**EXISTING CONDITIONS
BULL RUN LAND EXCHANGE**

PRELIMINARY PLAT FOR "WALKER PRAIRIE"

PROJECT: W01516 BULL RUN LAND EXCHANGE WITH USFS
DATE: 8-14-2019 (REV. 01-15-2020)
DRAWN BY: PAUL R. EJJIRD
CREW: PWB SURVEY
SHEET 1 OF 2

ONSITE SANITATION City of Portland – Bureau of Development Services
1900 SW 4th Avenue, Portland, Oregon 97201 – 503-823-6892 – TTY 503-823-6868 – www.portlandoregon.gov/bds
SEPTIC REVIEW CERTIFICATION (Land Use/Planning)

PRELIMINARY SUBDIVISION PLAT

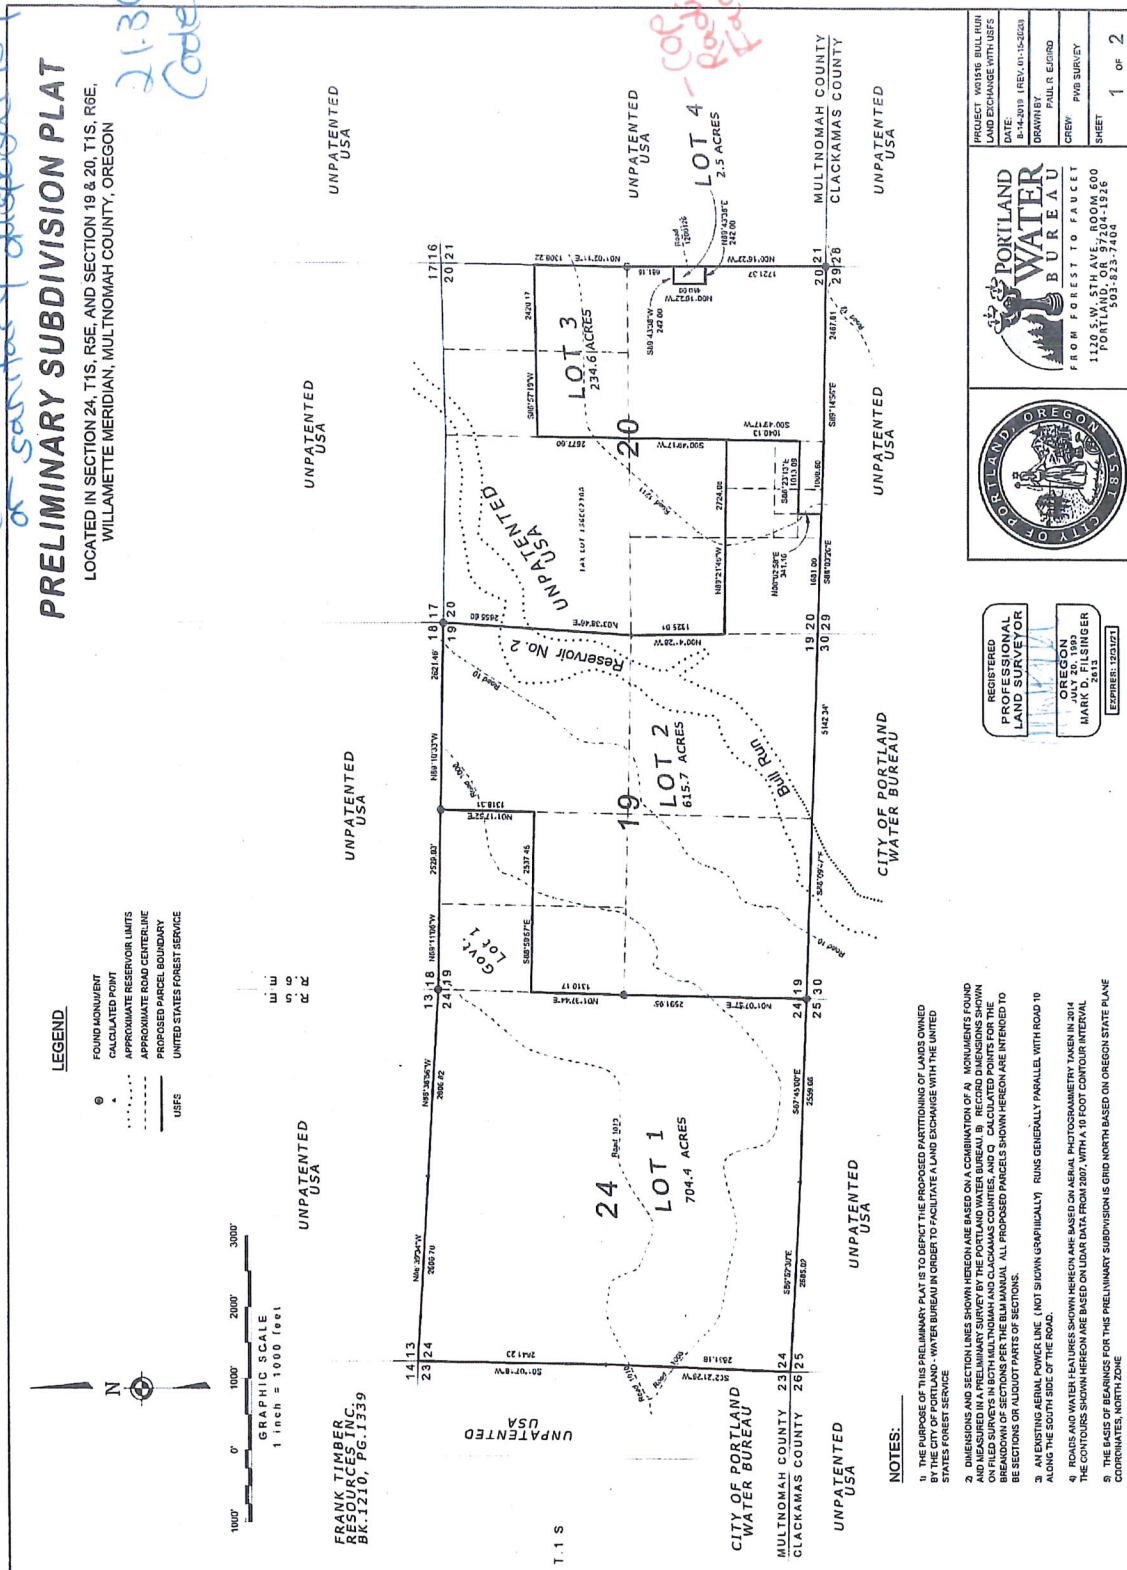
The proposed 4-lot Land Division in the Bull Run Watershed poses no concern to septic. No development or sanitary disposal is proposed. Per Portland City Code, Title 21 Water, 21.36.050 Bull Run Watershed Protection Policy, city lands within the closure area shall not be developed except as necessary to protect, enhance, operate, or maintain the water supply system + electric power generation + transmission
Lindsey Reschke 2/4/20
 Multnomah County Sanitarian Date
